**FINAL
Remedial Investigation Report
for the
Radiation Technology Incorporated
Superfund Site, Operable Unit 3
Rockaway Township, New Jersey**

Re: Draft Remedial Investigation Report, OU3, dated August 6, 2013
Radiation Technology, Inc. (RTI)
Rockaway Twp. Morris County
SRP PI No. 019440; EA No. RPC000003

The New Jersey Department of Environmental Protection (Department) has completed its review of the Draft Remedial Investigation Report, Operable Unit 3 (OU-3), dated August 6, 2013 for the Radiation Technology Inc. (RTI) Superfund Site in Rockaway Township, Morris County, NJ submitted pursuant to CERCLA and the Technical Requirements for Site Remediation at N.J.A.C. 7:26E (TRSR). The Department has the following comments:

Figure 1-1

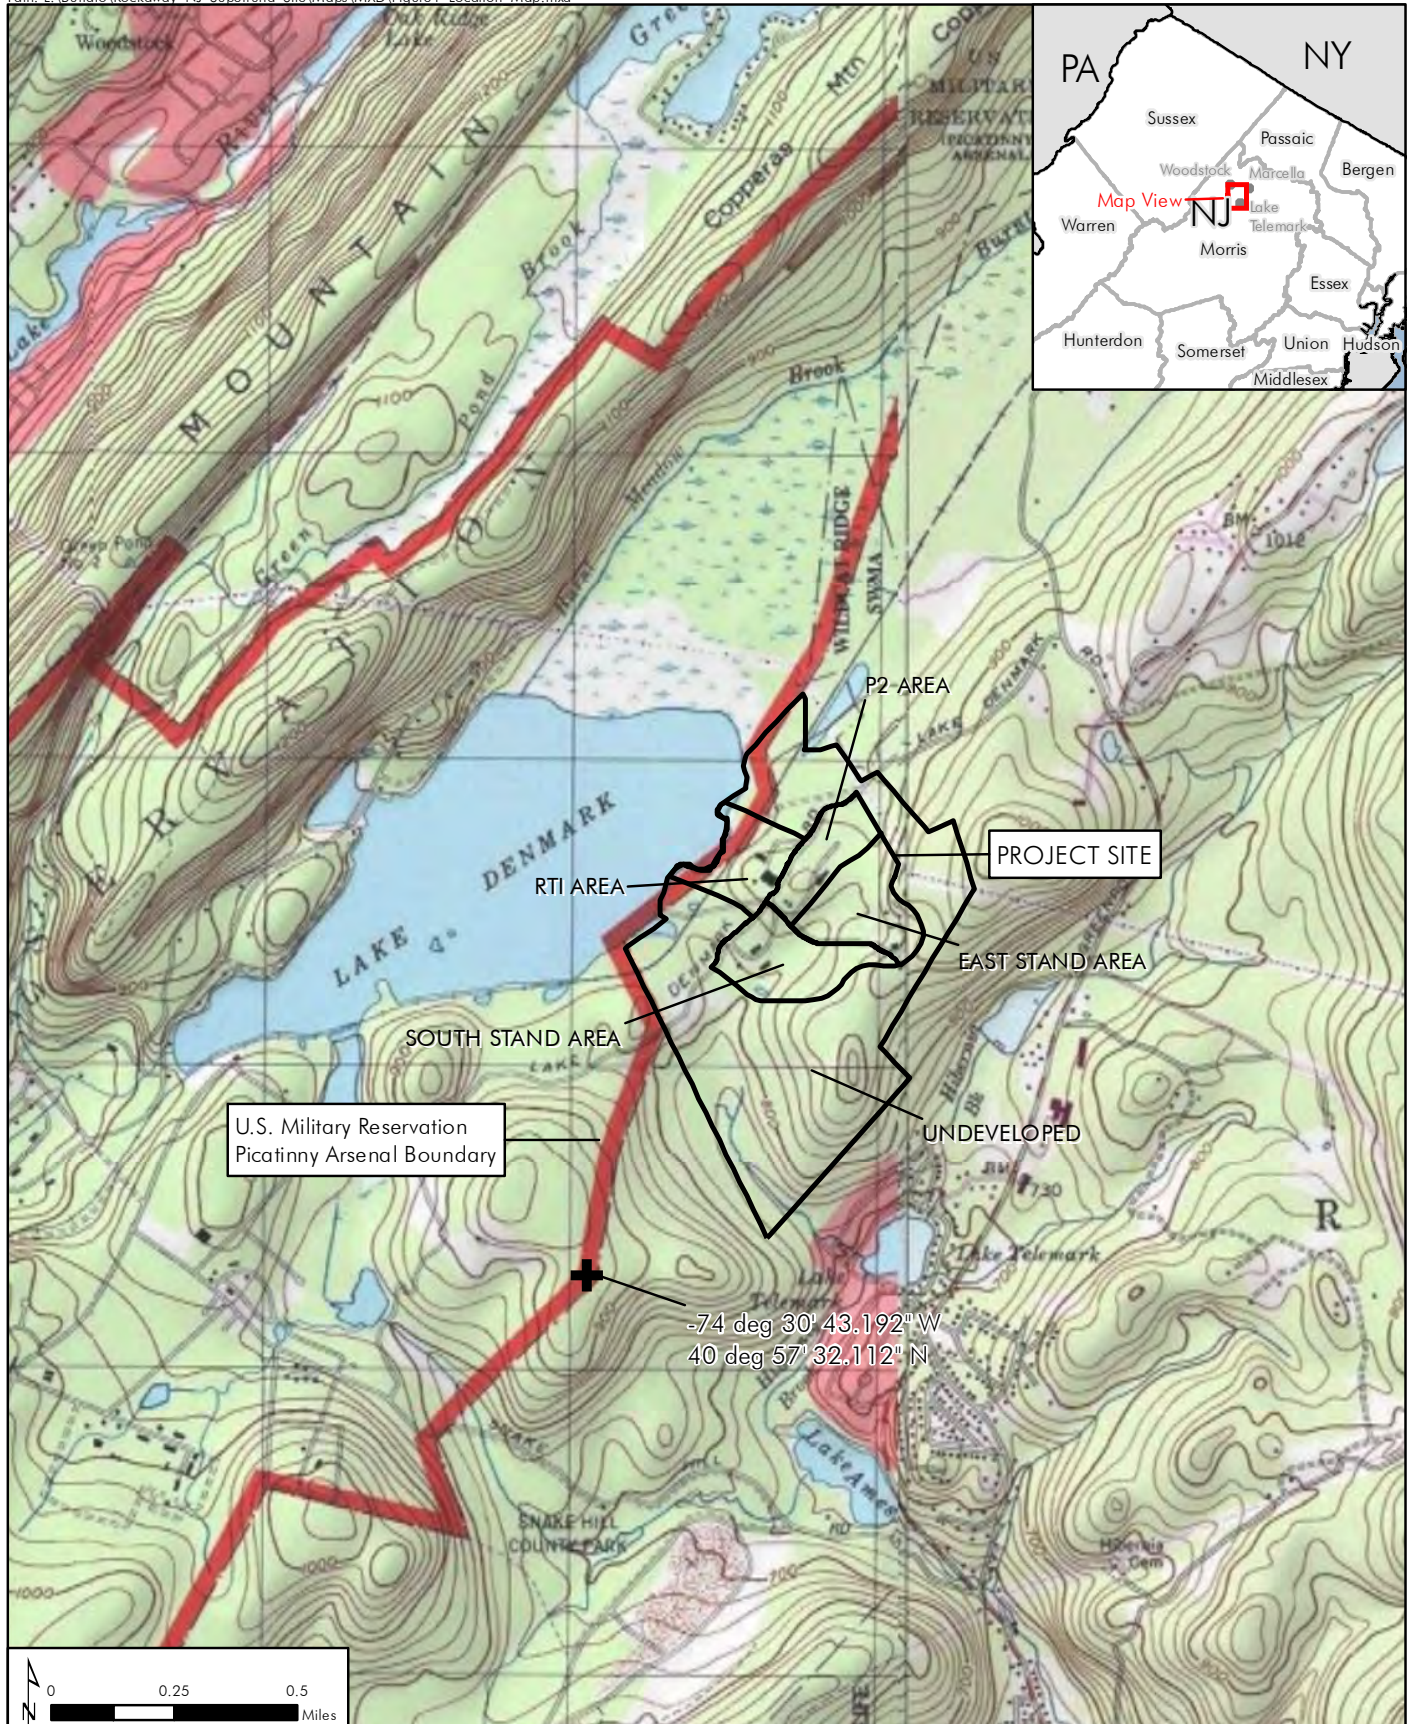
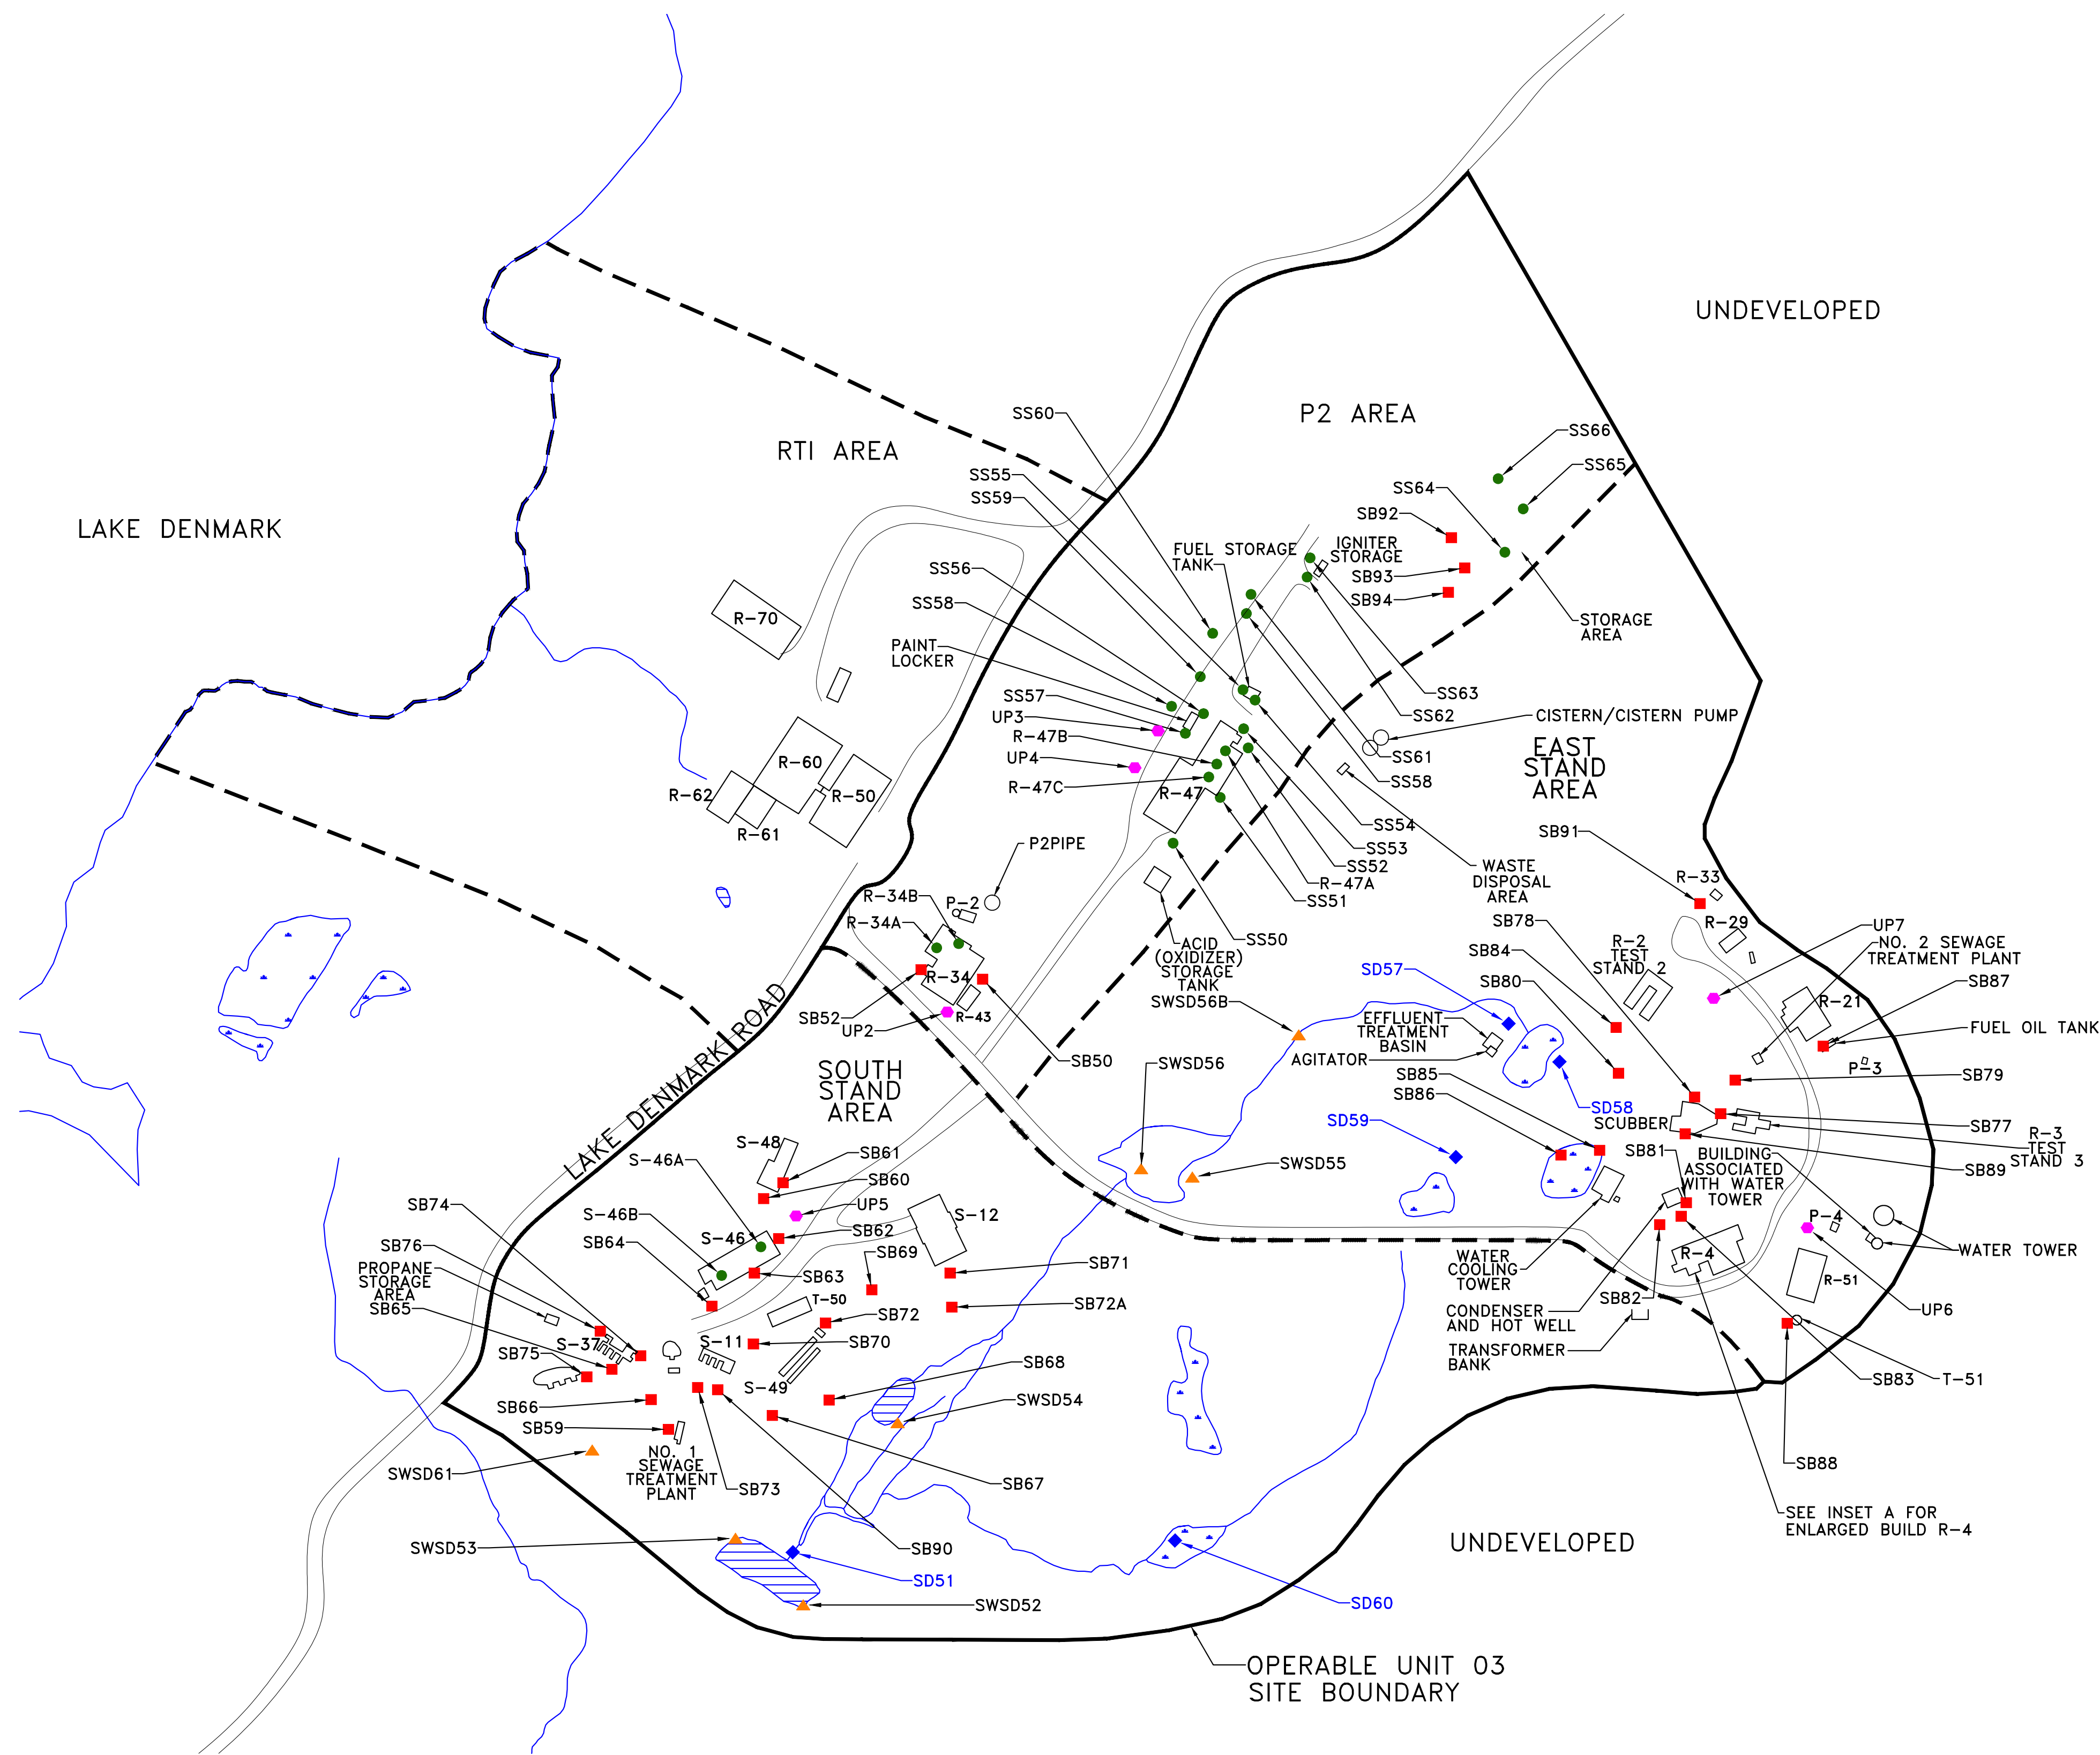
4. Figure 1-1 Site Location Map: Figure 1-1 outlines only the “Project Site” as defined by OU3 investigation (i.e. East Stand, South Stand, and P2 Areas). Figure 1-1 should be revised to outline/reference the entire site which also includes the RTI Area and the Undeveloped Land.

Response: Concur, the figure has been revised as requested.

FIGURE 2-19

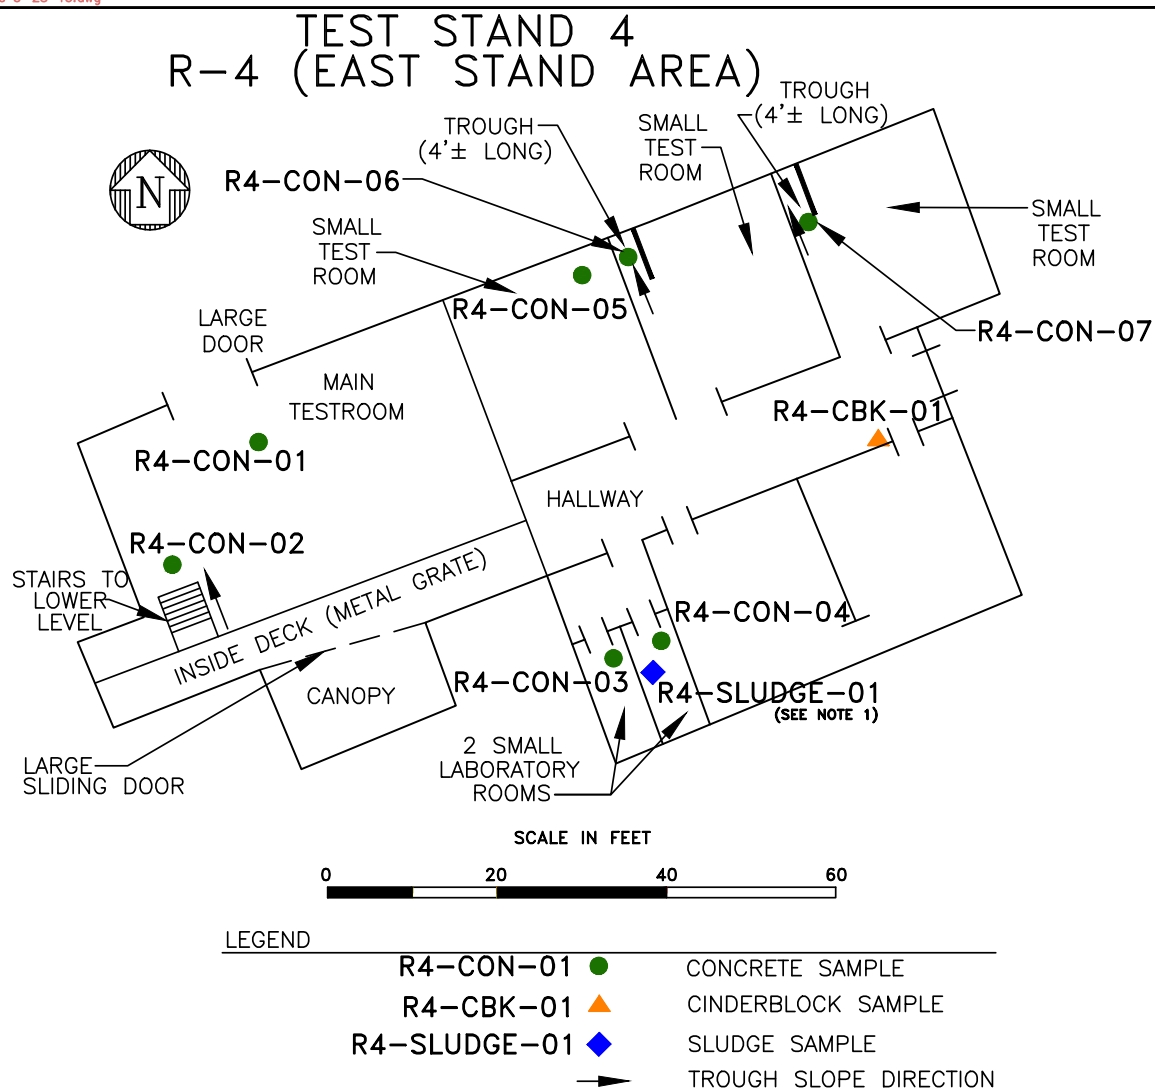
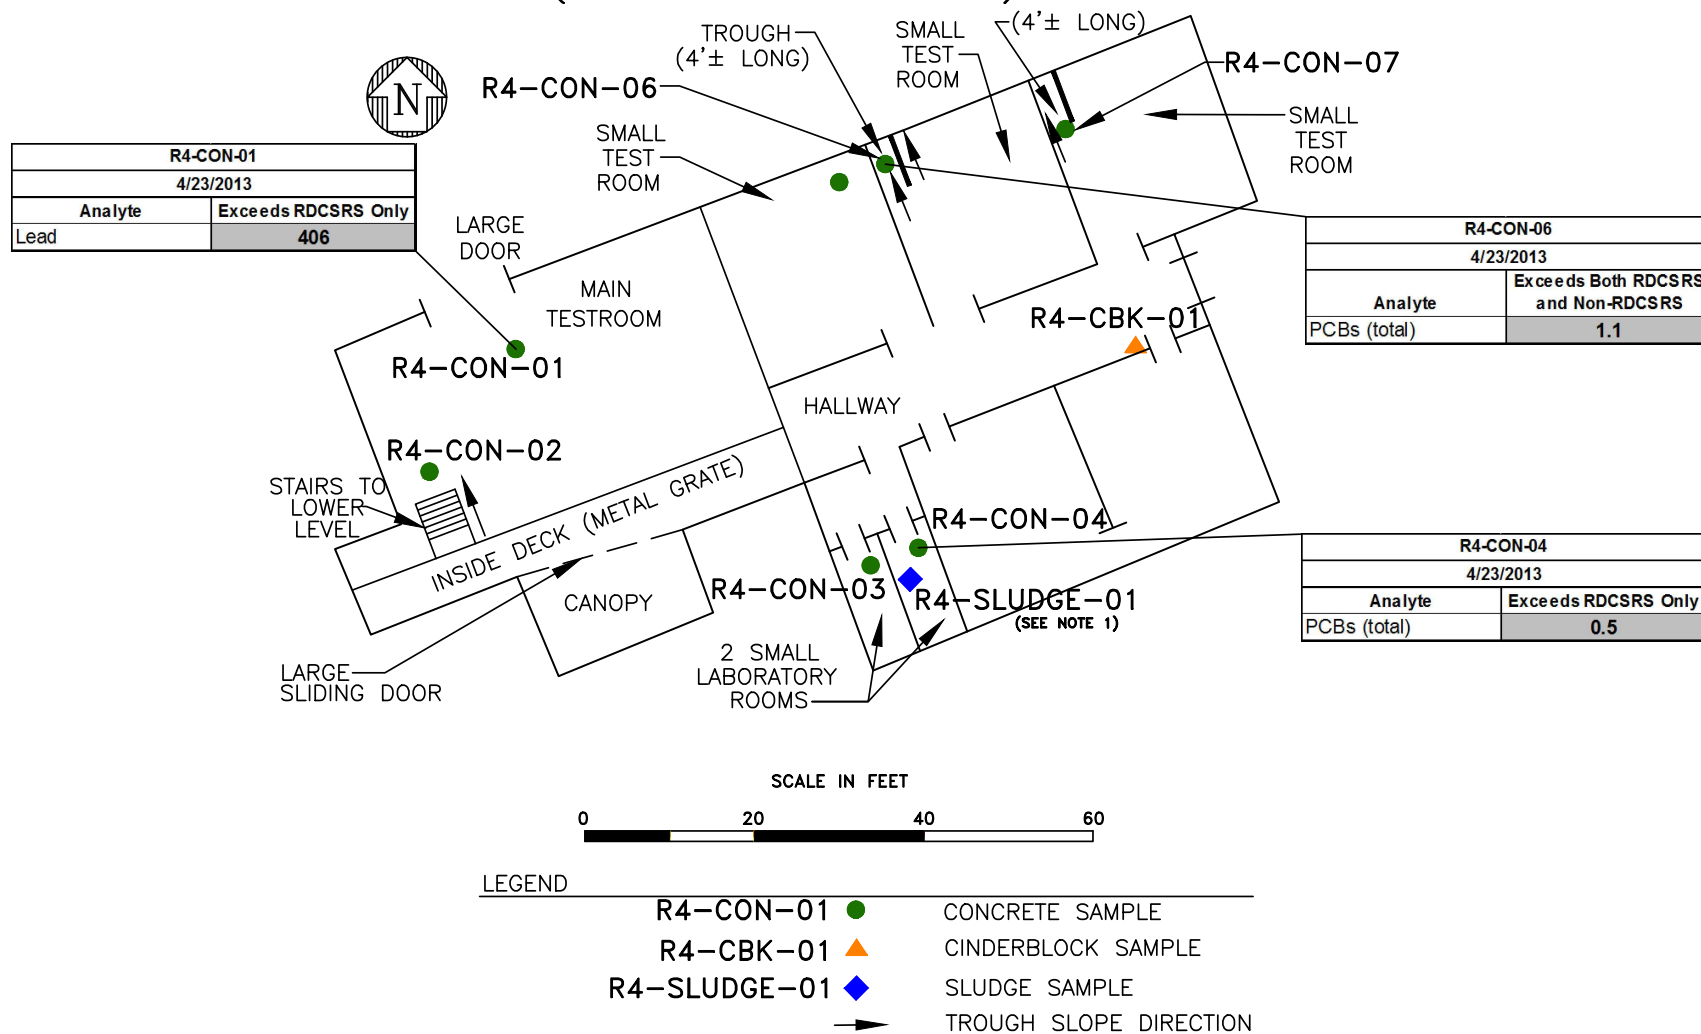
38. Section 4.4.7 Test Stand 4 (R-4), Page 4-30: The document states, “The samples were collected in the cracks in the concrete, stained areas, and downgradient areas of the troughs.” Figures 2-19 and 4-8 should be revised to include the above-referenced troughs.

Response: Concur, Figures 2-19 and 4-8 have been revised to include the troughs.

R-34 (P2 AREA)

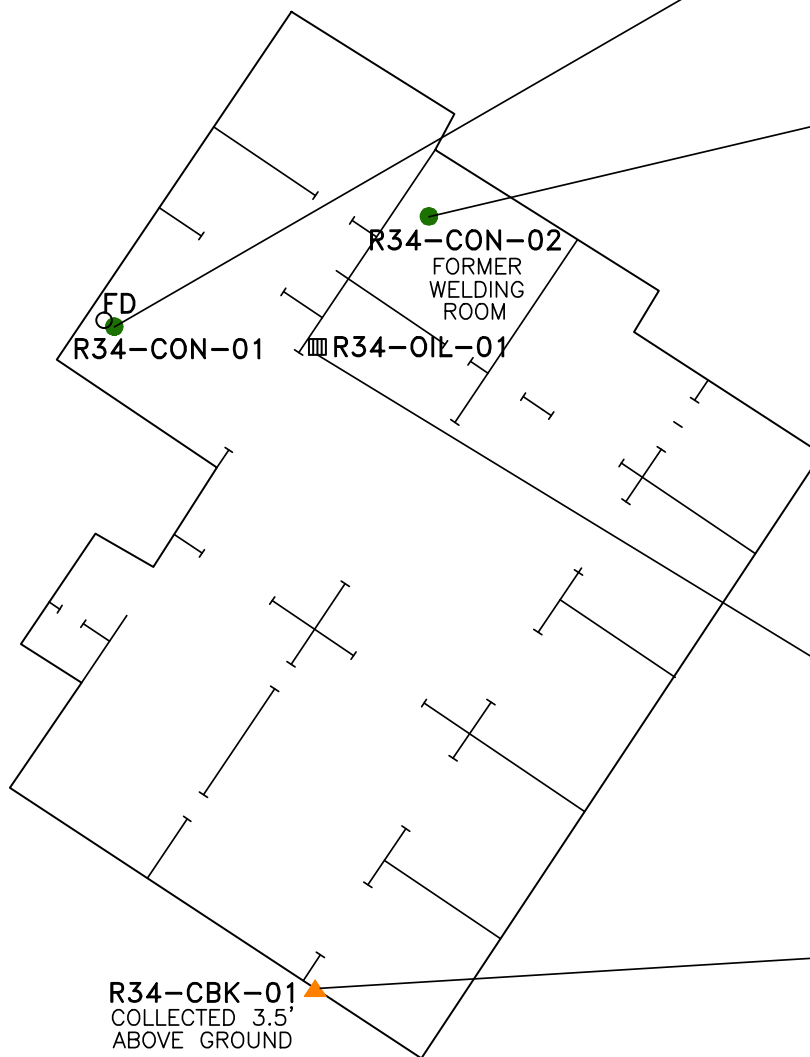
32. Section 4.2.4.2 R-34, Cinder Block Sample, Page 4-9: The document states, “One cinder block sample was collected...approximately 4 feet above the floor.” Whereas, Figure 4-3 notes the same sample was collected 3.5 feet above ground. The document should be revised to reflect the correct sample height for R34-CBK-01.

Response: Concur, revised as requested.
